Franklin County
Board of Commissioners

Technical Review Committee Agenda

November 19, 2025

i. JACK-25-05

REZONING SITE PLAN

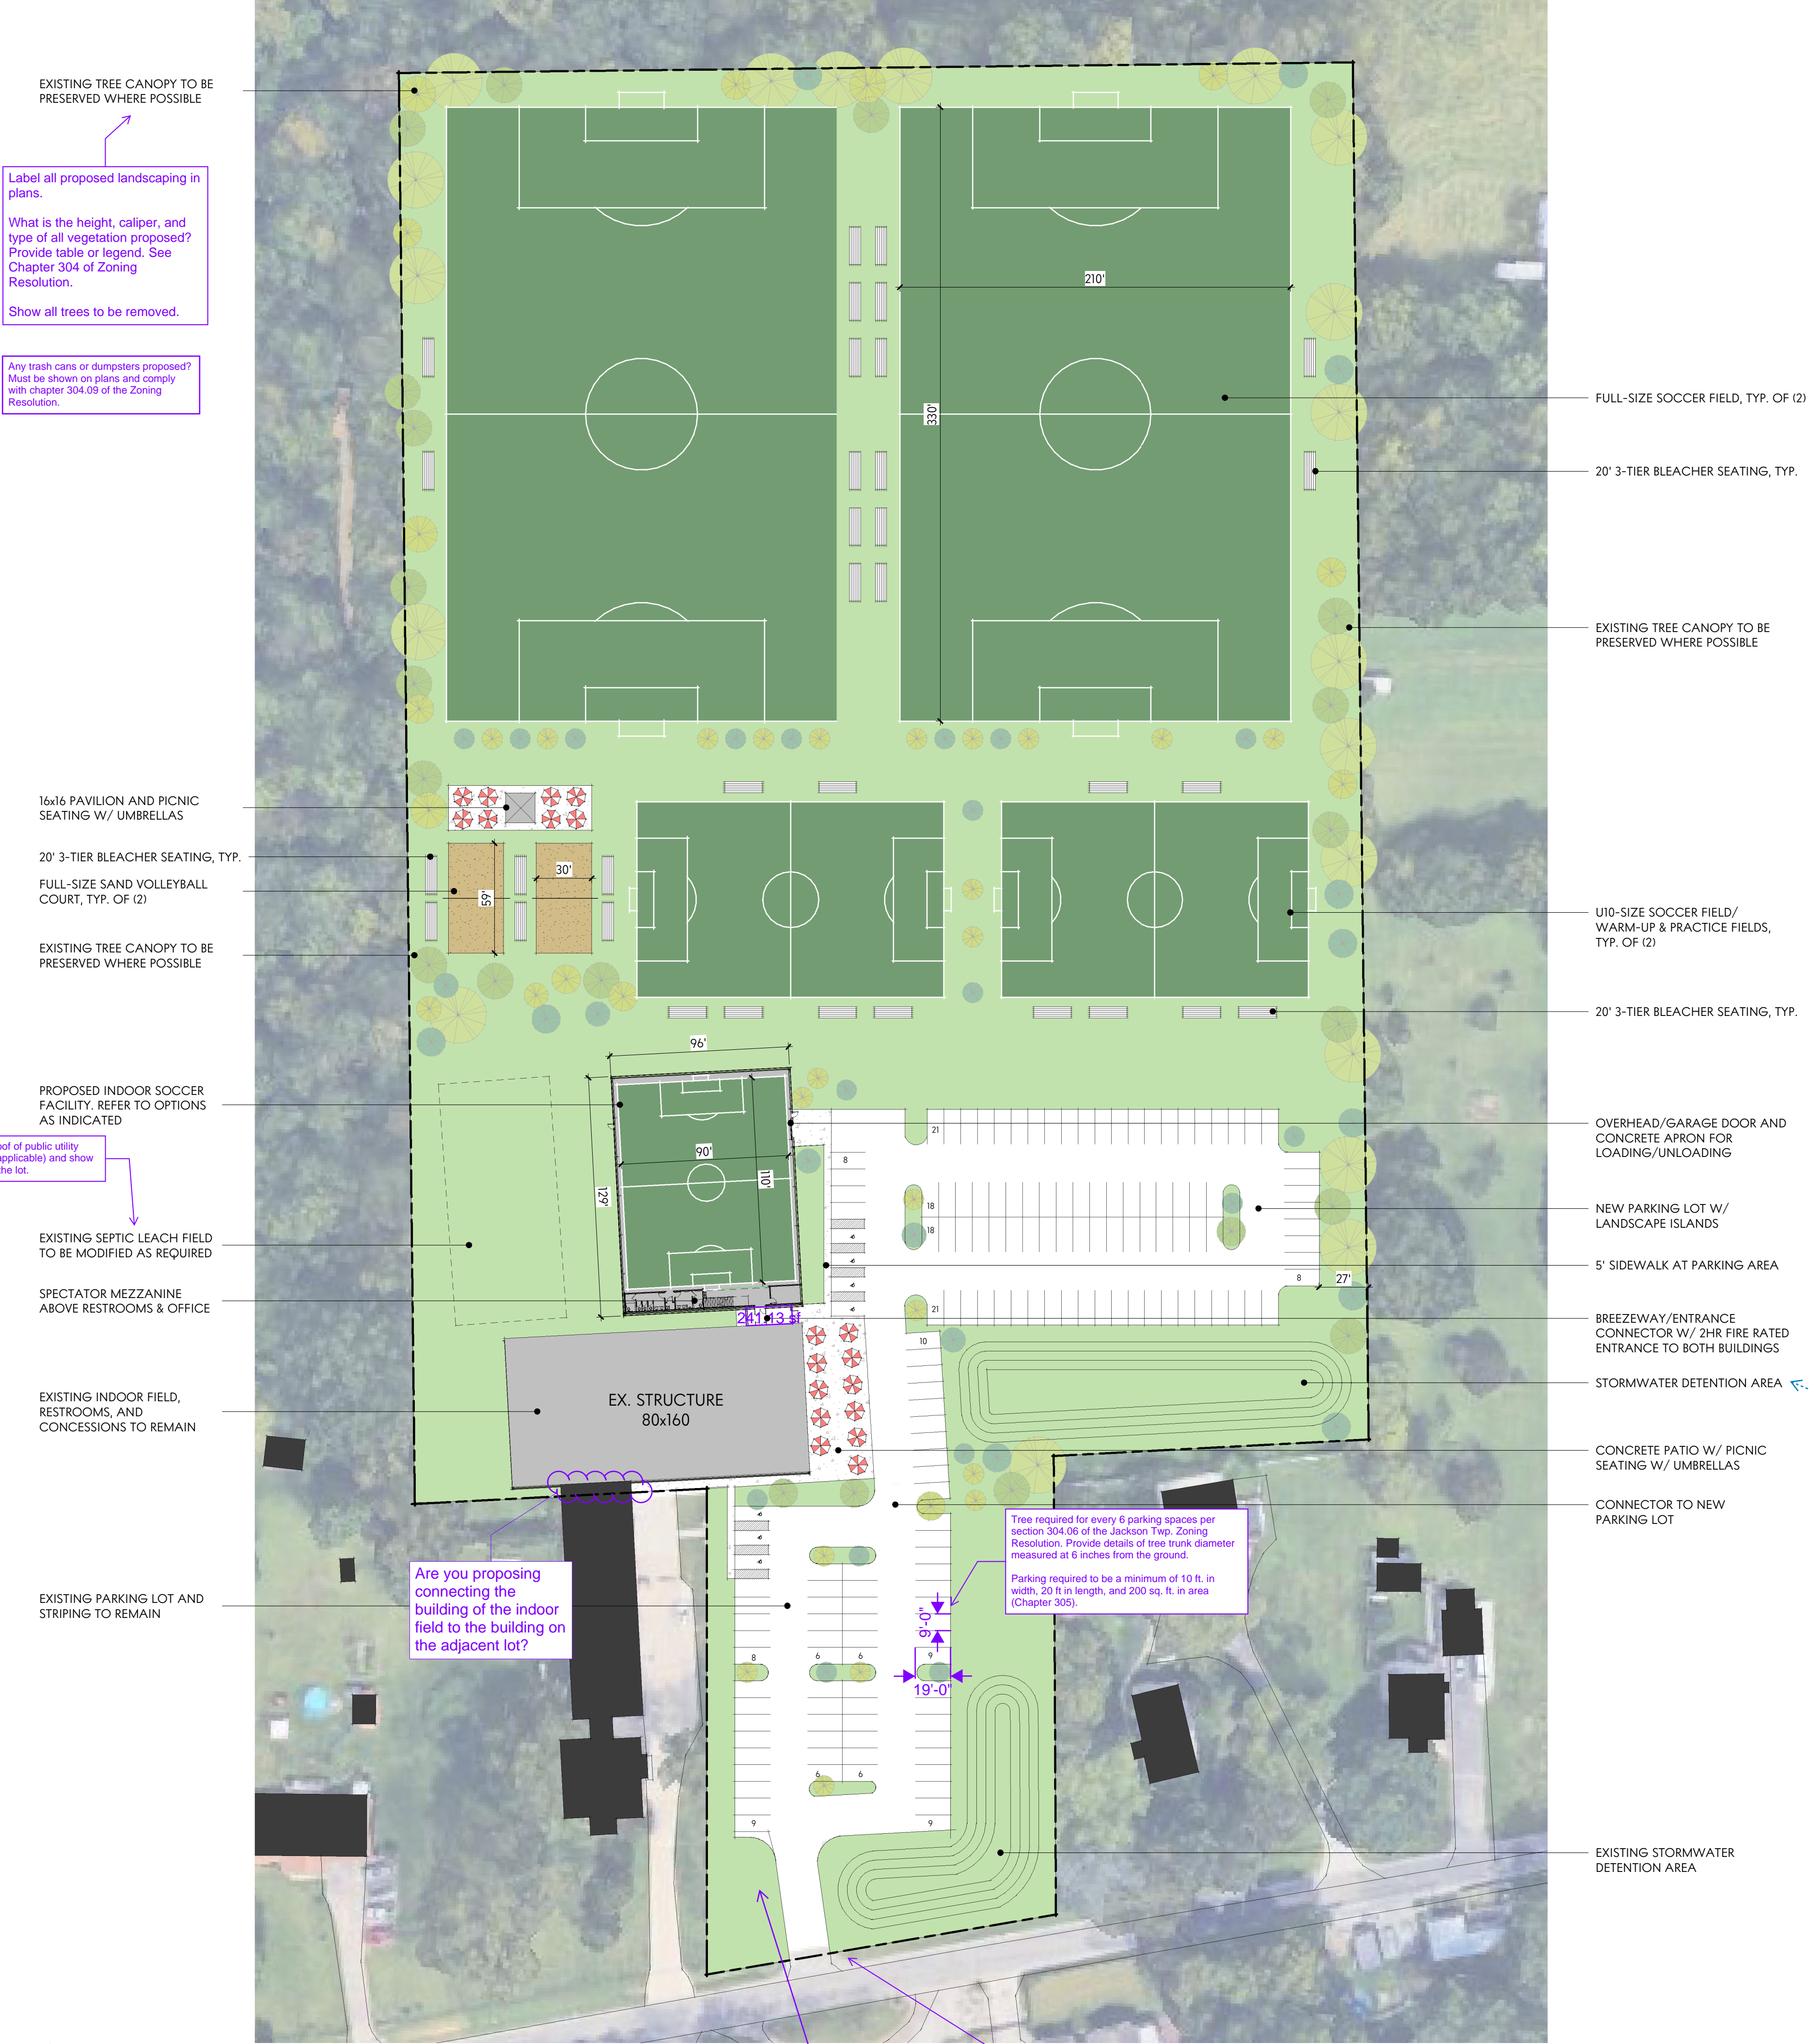
Plans identify the structure as 129x96 foot structure. Any landscaping, lighting, or signs proposed?

Full grading plans should also be created/submitted, as there is a lot of off-site drainage that travels through this parcel that will need accommodated.

Please provide the
stormwater report and a
new post-construction
O&M Plan that includes all
SCPs (existing and
proposed).
